**A D D E N D U M**

ADDENDUM No. <b>4</b>		GMCa JOB #: 202113 TDH
ISSUE DATE: 04.25.24		SBC #: 364/011-05-2021
PROJECT: Tennessee Tech University Derryberry Hall – Building Upgrades – Phase I		1 William L. Jones Drive Cookeville, TN 38505
OWNER: Tennessee Tech University		1 Bridgestone Park, 3 <sup>rd</sup> Floor Nashville, TN 37214
ARCHITECT: Gilbert McLaughlin Casella architects		2305 Kline Ave, Suite 200 Nashville, TN 37211

TENNESSEE TECH UNIVERSITY  
**DERRYBERRY HALL**  
 BUILDING UPGRADES - PHASE I  
 1 WILLIAM L. JONES DRIVE  
 COOKEVILLE, TN 38505

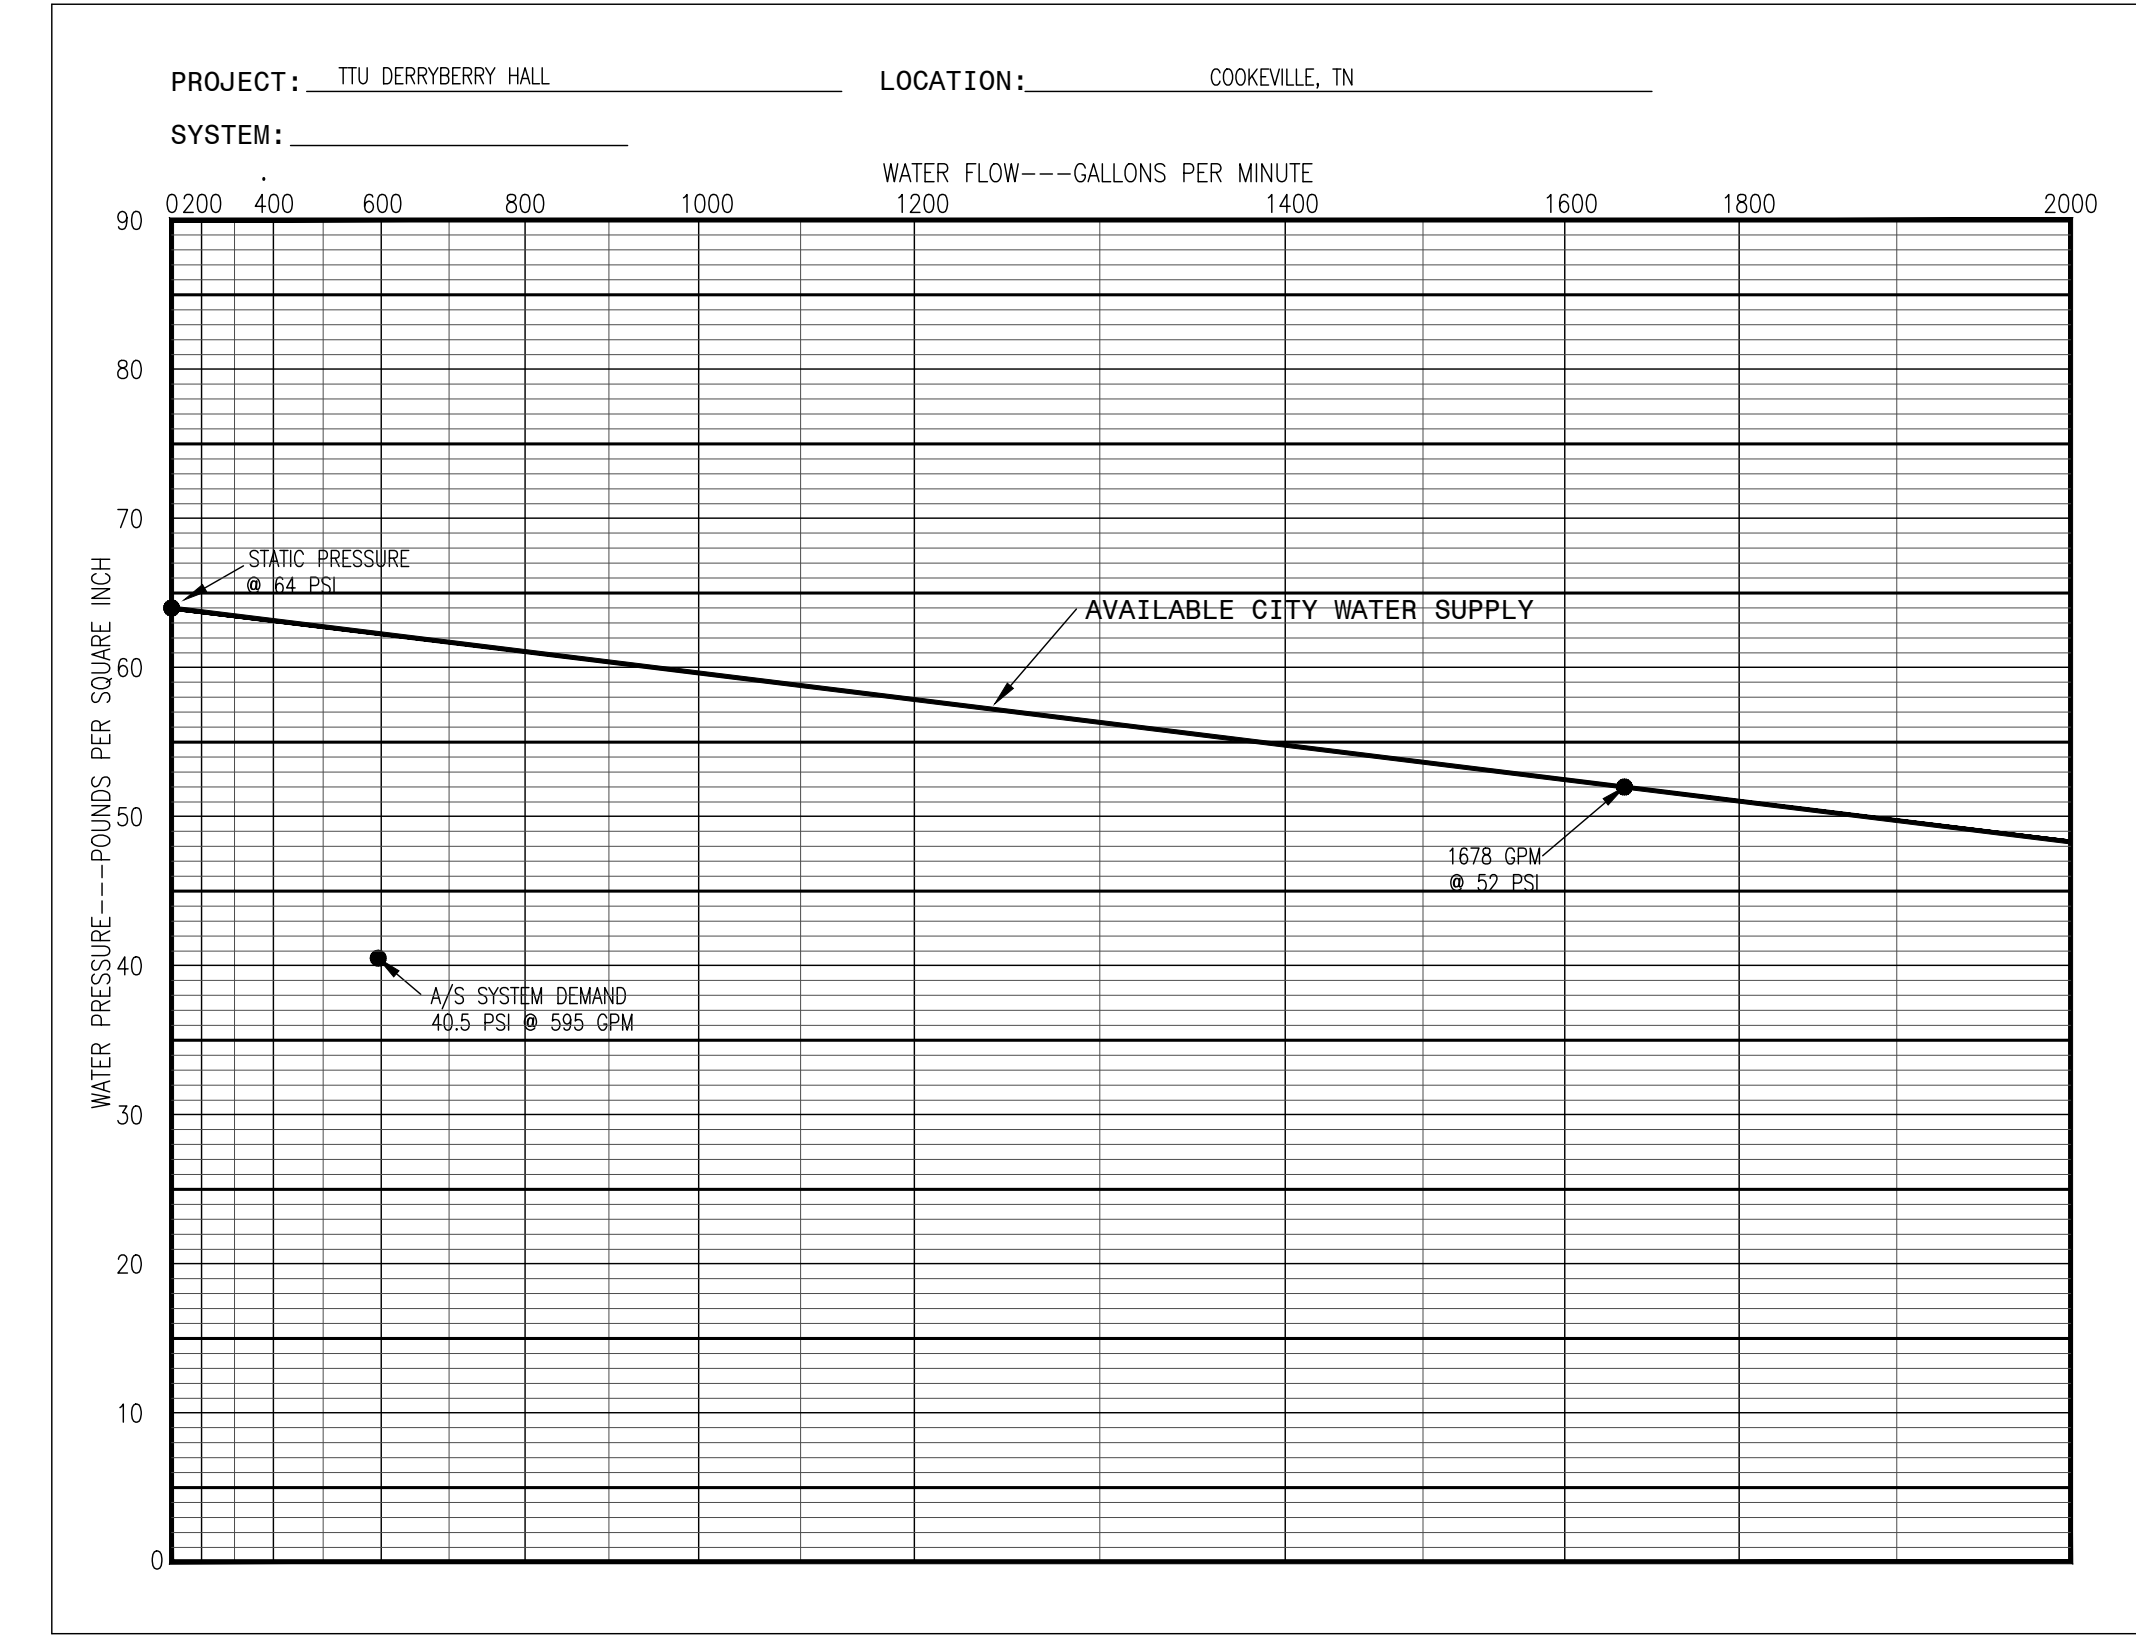
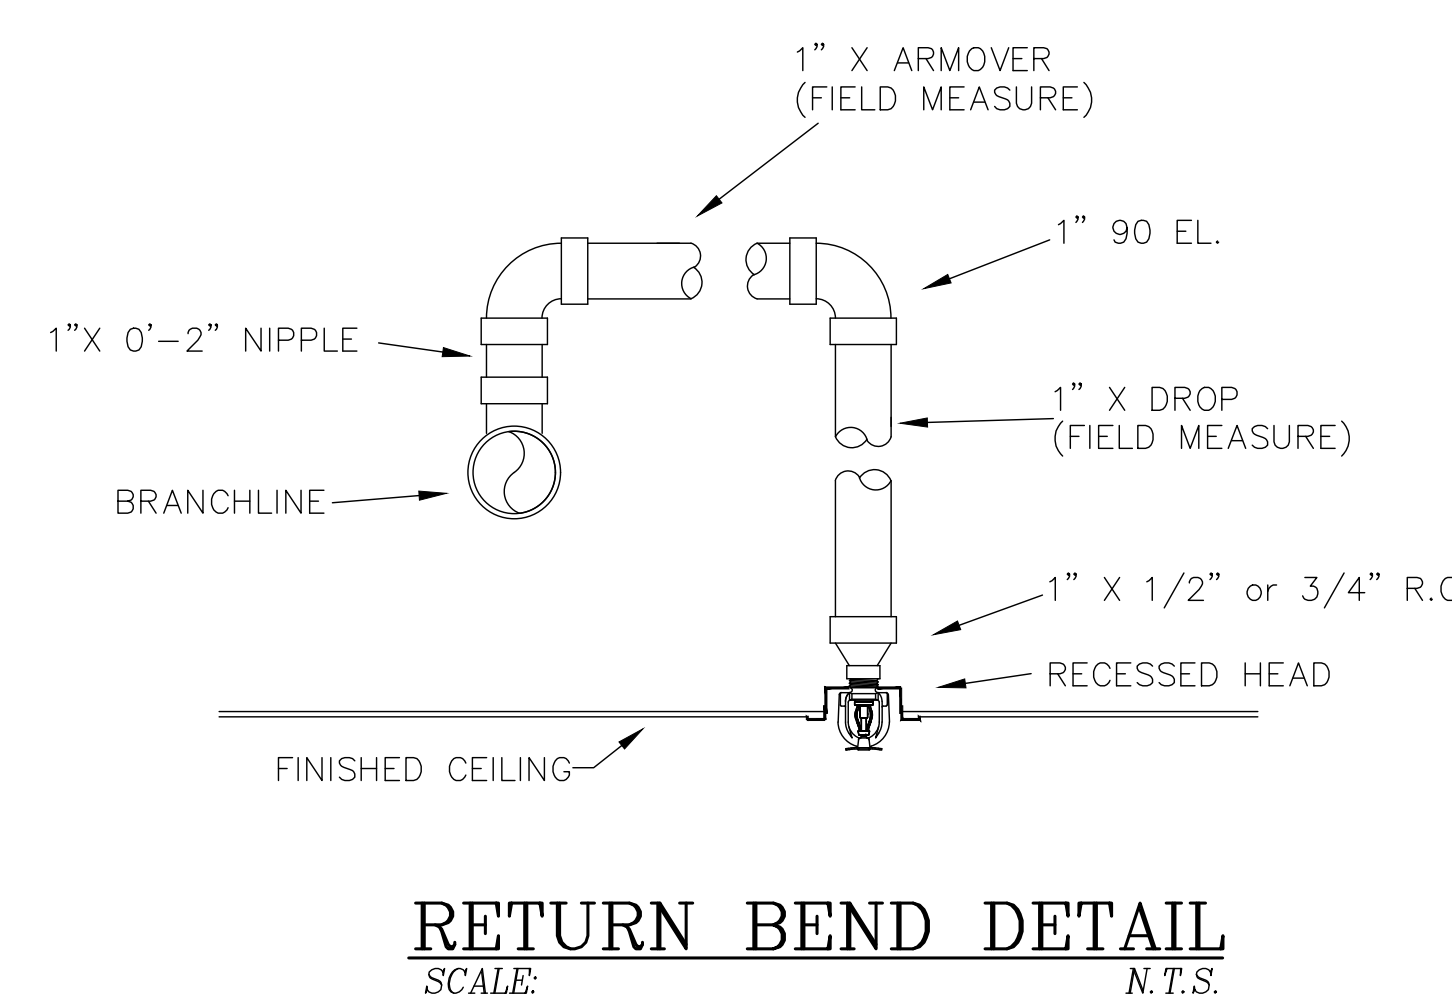
- a) **Per SFM Comments:** Added typical seismic details and notes.
  - b) **Per SFM Comments:** Added required duration of water demand.
  - c) **Per SFM Comments:** Revised flow test date, time, location, and person information.
